HISTORIC PRESERVATION REVIEW BOARD FINAL STAFF REPORT AND RECOMMENDATION

Historic Landmark Case No. 19-06 Scottish Rite Temple amendment (boundary increase) 1733 16th Street NW Square 192 Lot 108

Meeting Date:May 23, 2019Applicant:Dupont East Civic Action AssociationAffected ANC:2B

Baist's Real Estate Atlas of Surveys of Washington, District of Columbia, Vol. 1, Plan 19, (1965), with lot 800 delineated in red.

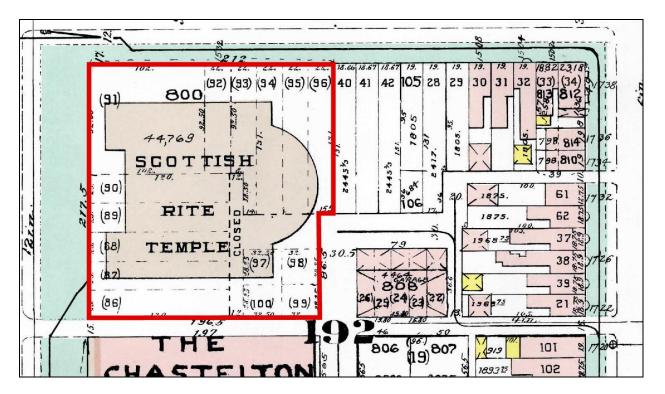
Logically, boundaries should reflect the extent of the property at the time of the Temple's completion in 1915, which was Assessment and Taxation Lot 800. Lots 40-42 (purchased 1920), 105 (1921), 106 (1952), 28 (1954) and 29 (1963) were acquired by the Scottish Rite in later years, as noted. As the 1965 Baist real estate atlas indicates, these eastern lots had not been formally consolidated with the temple by subdivision, or even informally, by the creation of an A&T lot.

Based upon additional research, HPO requests that the Board resolve the ambiguity of the landmark's present boundary by confirming it as the extent of former Assessment & Taxation Lot 800 upon which the temple stood when completed in 1915. This lot is outlined in red on the 1965 map below.
